101 PRIMROSE STREET
CHERRY CHASE VILLAGE H.O.

MONTGOMERY COUNTY HISTORIC PRESERVATION COMMISSION
STAFF REPORT

Address:	101 Primrose Street, Chevy Chase	Meeting Date:	3/13/13
Resource:	Contributing Resource Chevy Chase Village Historic District	Report Date:	3/6/13
Applicant:	Tammy Harris (Karen Mulligan, Agent)	Public Notice:	2/27/13
Review:	HAWP	Tax Credit:	No
Case Number:	35/13-13J	Staff:	Karen Theimer Brown

PROPOSAL: window replacement and enclosure of second-story balcony

2 SOUTH ELEVATION PROPOSED
 SCALE 1/4" = 1'-0"

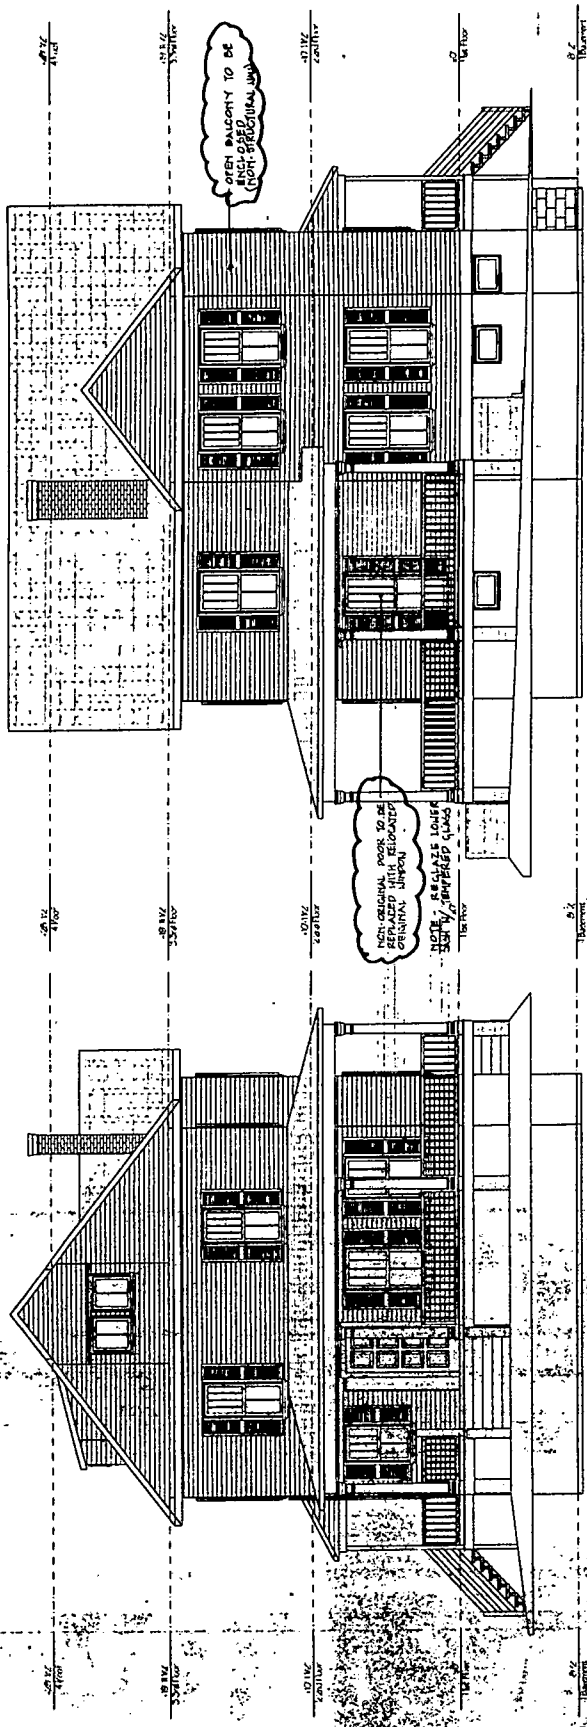
The applicant is proposing to remove a door on the south elevation (Primrose street side). Per the applicant, there is an inconsistency between the interior details of this opening (profiles, interior casing and height) with other openings in the room, so it is not believed to be an original feature. Because there is an exterior door on both the Primrose and Brookville elevations, it appears somewhat that the house has two front façades. The Brookville elevation was the historical (original) front of the house. By removing the door on the Primrose side and replacing it with a window, the Brookville elevation will read as the primary façade, and only one exterior door will lead into the living room.

The applicant is also proposing to replace the added door on the south elevation (Primrose street side)

with an original window that will be relocated from the second floor east (rear) elevation. This second story window faces the porch/balcony on the southeastern corner (rear and side elevation) of the dwelling. In reviewing Sandborn maps, an indentation existed in this corner of the house as early as 1927. Currently there is no doorway into the porch, just this window. The applicant is proposing to relocate that window to the location where the door will be removed on the Primrose (south) elevation. The porch will subsequently be enclosed with like materials, and a new custom window with like profiles will be added on the rear (east) elevation in the new wall. The custom made single pane wood window will have true divided lights, and sash and muntin bars that replicate the size and light division of the existing second floor window. This window is proposed to preserve the symmetrical arrangement of windows on the rear elevation but would not be operable.

Using the guidelines and applying a moderate level of scrutiny, staff finds that the application is consistent with the Chevy Chase Village Historic District Guidelines and supports the removal of the door, the installation of the relocated window and a new window, and the enclosure of the porch as proposed. The historic window will be relocated to an historic opening, the new window will be located in the new framing, and the original front façade, the Brookville elevation, will continue to read as the original front of the house. The applicant has also proposed the use of historic materials for the siding and replacement window. All these factors preserve the integrity of this contributing structure, and as per the Guidelines, the alterations are proposed in such a way that the altered structure will still contribute to the district. Staff recommends approval.

1 EAST ELEVATION PROPOSED
SCALE: 1/4" = 1'-0"

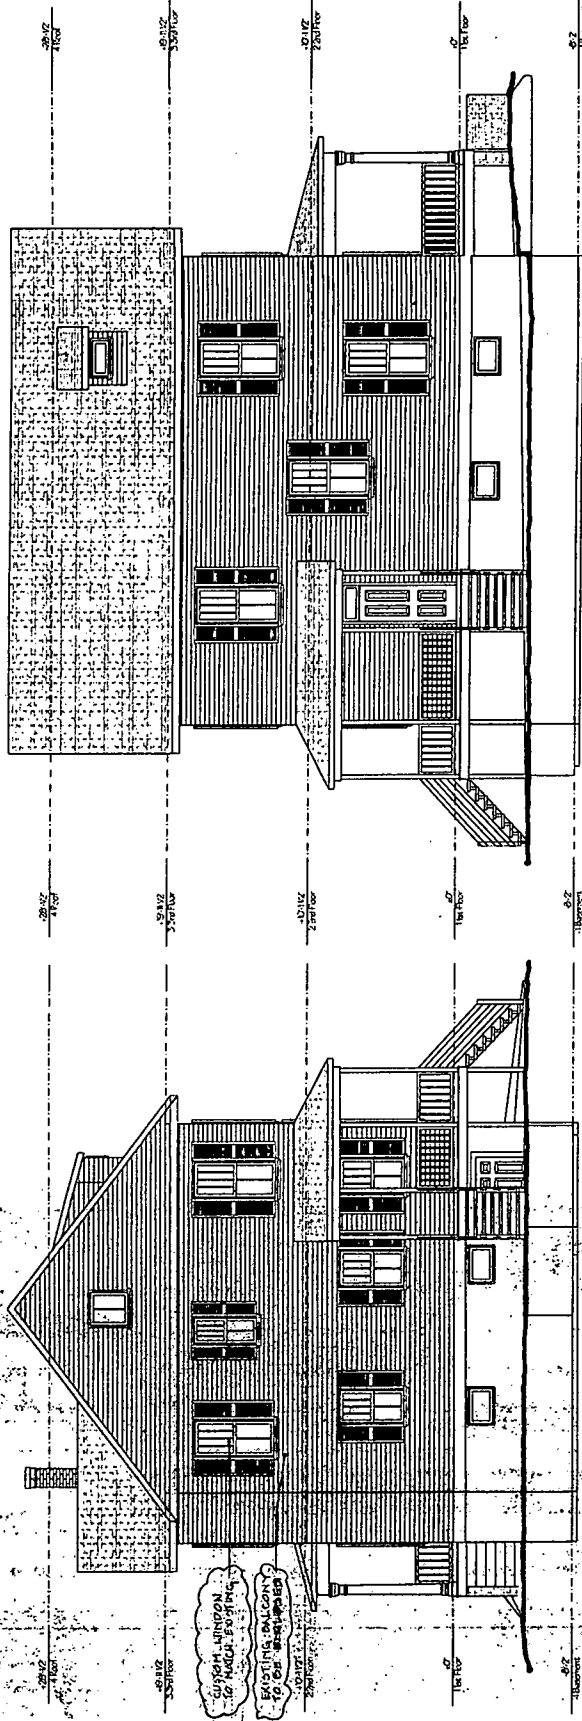
A single custom made wood, single pane glass, true divided lite, sash that replicates the size and light division of the existing second floor double hung windows on that elevation. The muntin bars would match the existing with a horizontal bar that matches the width of the double hung check rail. It would be set in a jamb with exterior casing to match the existing double hung windows on that elevation but would not be operable.
